Subject: Unauthorized Waste Management, Incomplete Site Investigation, and Responses to

C. Reiss Coal Dock Property, City of Superior, Douglas County, WI

Parcel IDs 04-804-01014-00 and 04-804-01003-00 DNR BRRTS Activity #02-16-589248, FID #816130810

On 30 January 2024, Stantec submitted a *Supplemental Site Investigation Report* for the C. Reiss Dock Property, BRRTS Case No. 02-16-589248, dated 29 January 2024 (SSIR), on your behalf. A fee for DNR review of the SSIR was not included, but we are providing a review given the complexity of the Site.

Exhibit 1
C. Reiss Coal Dock., BRRTS # 02-16-589248 Monitoring Well MW20

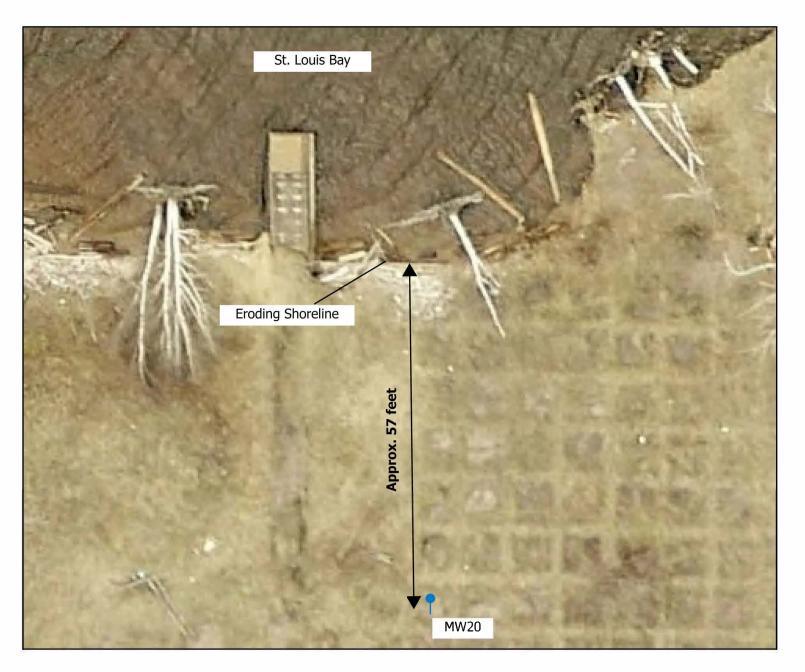
Prior to its destruction in December 2023, monitoring well MW20 was sampled twice for arsenic, on 2 May 2023 and 21 June 2023, with results of 17 and 20 mg/L, respectively. These results exceed the public health groundwater standards for arsenic: enforcement standard (ES) of 10 mg/L and preventive action limit (PAL) of 1 mg/L in Wis. Admin. Code ch. NR 140, Table 1. The location of MW20 is about 57 feet from the shoreline of the

St. Louis River. The shoreline immediately north of MW20 is eroding based on observations of bare soil and measurable changes in air photos available from Douglas County, including the increasing area of the exposed concrete structure. Arsenic is carcinogenic, and although not directly comparable, groundwater contaminant concentrations would exceed applicable surface water criteria for arsenic in Wis. Admin. Code ch. NR 105 (Exhibit 1).

In response to exceedances of the ES, under Wis. Admin. Code § NR 140.26, the DNR is requiring quarterly groundwater monitoring in the MW20 area to assess trends in groundwater quality and evaluation of options for an interim action or remedial action for arsenic in the MW20 and eroding shoreline areas prior to redevelopment activities. Additionally, residual soil contamination shall not adversely affect surface water per Wis. Admin. Code § NR 720.07(1)(c).
